* SHED ROOF DORMER *

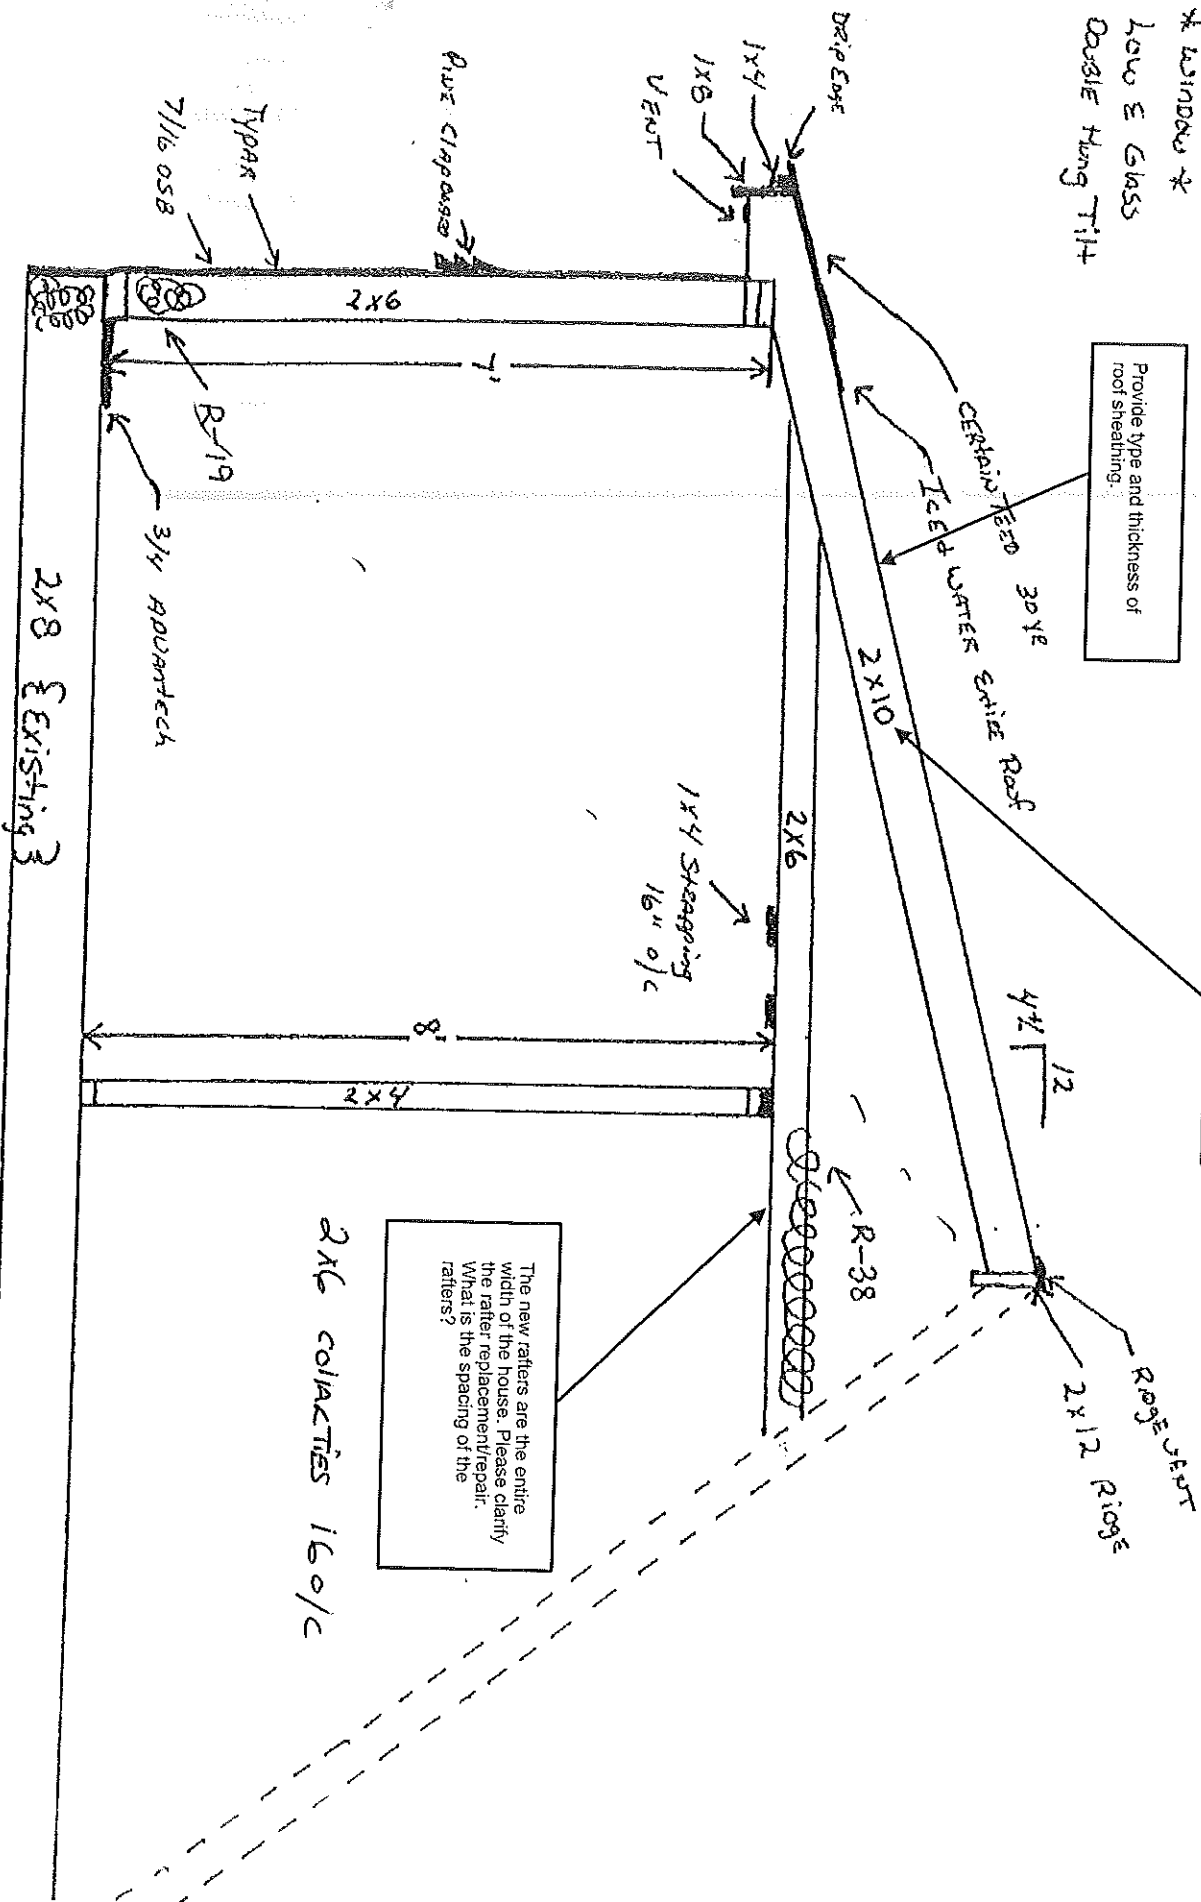
Provide type and thickness of roof sheathing.

Provide spacing of roof joists for shed dormer.

The new rafters are the entire width of the house. Please clarify the rafter replacement/repair. What is the spacing of the rafters?

5/8 OSB

16 o/c

2x6 RAFTERS 16 o/c
